Responses to Reviews of manuscript "A near-global eddy-resolving OGCM for climate studies" (gmd-2016-17) by X. Zhang, P. R. Oke, M. Feng, M. A. Chamberlain, J. A. Church, D. Monselesan, C. Sun, R. J. Matear, A. Schiller and R. Fiedler.

Short comment #1 by Y. Yu

Figure C. Zonal mean heat flux (W/m^2) from our OFAM3-JRA55 model run and ECMWF Interim Reanalysis (upper panel) and OAFlux (lower panel). All flux components and net heat flux are defined positive when the ocean gains heat.

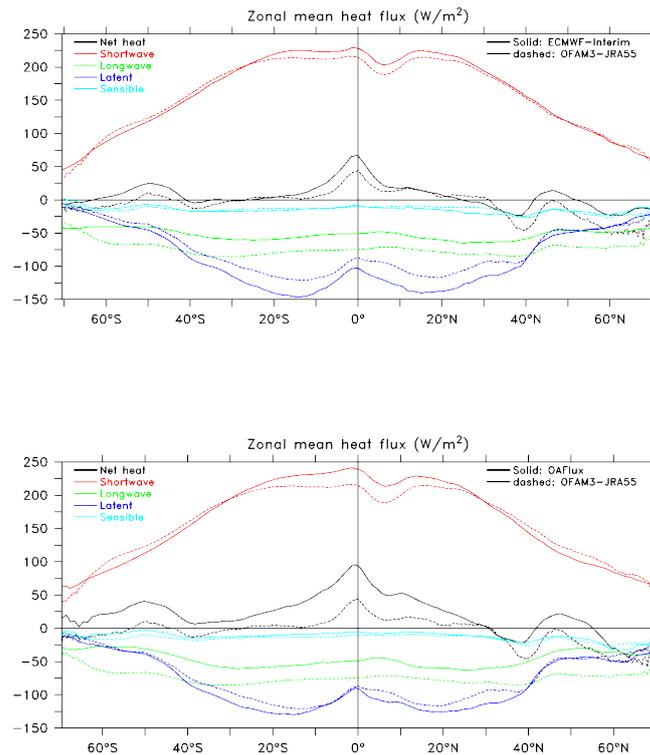
30 2. As you mentioned in page 4, bulk formula as suggested by Large and Yeager (2004) are applied to calculate the turbulent heat flux and moment flux at the sea surface? However, I am very curious that you have to apply for a large heat correction more $16\text{W}/(\text{m}^2\cdot\text{m})$. Is it resulted from overestimated downward radiation flux in JRA55?

40 3. Because of large heat flux correction, I suggested that the authors had better show comparison of zonal mean shortwave and longwave radiation from JRA-55, OAFLUX or other available observation.

35 We chose to modify downward longwave radiation for the ease of implementation. Since bulk formula is used to calculate heat flux, and some air-sea feedback mechanisms can lead to compensation among different components. In fact, in our model experiment, reduced downward long wave radiation is mainly compensated by less heat loss through latent heat flux (see Fig. C below).

Upon your suggestion, we compared the zonal mean heat flux component from our model experiment with ECMWF Interim Reanalysis and OAFlux, and found the comparison is quite good (See Fig. C below). Nonetheless, the comparison is better with Interim Reanalysis, since OAFlux has a (unrealistically) large positive mean global net flux around $30\text{ W}/\text{m}^2$. The upper panel of Fig. C is now included in the manuscript.
